Access Compliance Report

Public Rights-of-Way

Intersection ID: 51473	Main Street: LILLIESLEAF_GLENN_LN	Cross Street: TAMARRON_DR	Location: SW
ADA ID: 53F819AB9DF1	Ramp Type: BlendTrans1	Initial Pass/Fail: Pass	Overall Compliance: No
Severity Score: 5			
Codes/Mitigation Info/Possible Solution		Field Measurements/Component Compliance

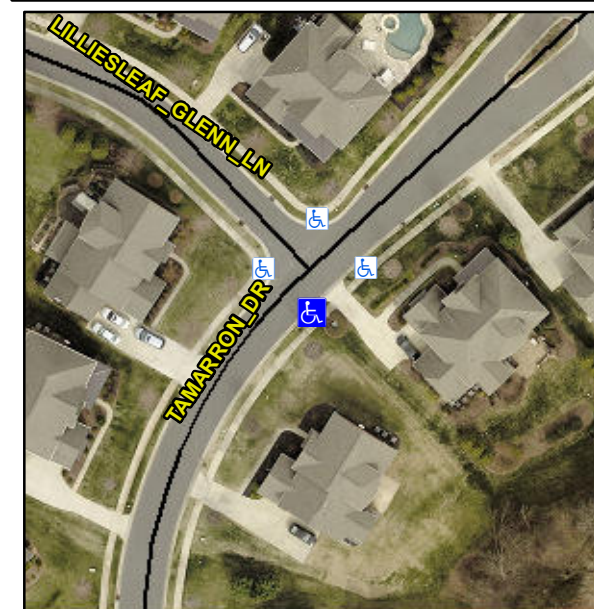
Not Found, R304.2.2-Perp, R304.3.2-Para, R305.2, R304.5.4

Compliance	Description	Data	Compliance	Description	Data
N/A	Ramp Length (in)	47.0	Yes	BlendTrans Slope (%)	4.9
Yes	Ramp Width (in)	48.0	Yes	BlendTrans XSlope (%)	1.3
N/A	Flare Type LT	Sloped	N/A	Flare Type RT	Sloped
N/A	Flare Slope LT (%)	4.8	N/A	Flare Slope RT (%)	3.2
N/A	Flare Traversable LT?	No	N/A	Flare Traversable RT?	No
Yes	Landing Length (in)	48.0	Yes	DWS Provided?	Yes
Yes	Landing Width (in)	48.0	Yes	DWS Contrast?	Yes
No	Landing Slope (%)	6.1	Yes	DWS Length (in)	24.0
Yes	Landing X Slope (%)	1.3	Yes	DWS Full Width?	Yes
N/A	Landing Curb? (Y/N)	No	No	DWS Offset (in)	4.0
N/A	Shared Landing?	No			
Yes	Gutter Ponding?	No	No	Gutter Slope (%)	8.5
Yes	Gutter Lip Ht (in)	0.0	Yes	Gutter X Slope (%)	0.4
N/A	Painted X Walk1?	No	N/A	Painted X Walk2?	N/A
	X Walk 1 Direction	To NW		X Walk 2 Direction	N/A
	X Walk 1 Width (in)	N/A		X Walk 2 Width (in)	N/A
	X Walk 1 Slope (%)	4.5		X Walk 2 Slope (%)	N/A
	X Walk 1 X Slope (%)	1.3		X Walk 2 X Slope (%)	N/A

N/A	Ramp inside XWalk1?	N/A	N/A	Ramp inside XWalk2?	N/A
	Road Slope (%)	1.3		Clear Space?	Yes
	Road X Slope (%)	4.5	N/A	Clear Space to XWalk (in)	N/A
Yes	Any Obstructions?	No	Yes	Storm Grate/Utility Hazard?	No
	Obstruction Type			Storm Grate/Utility Type	
		N/A			N/A
			Yes	Surface Condition? (G/P)	Good
			No	Curb Slope (%)	14.0

Remove & Replace Curb Ramp With Two New Directional Ramps or Equivalent. Remove & Replace Gutter.
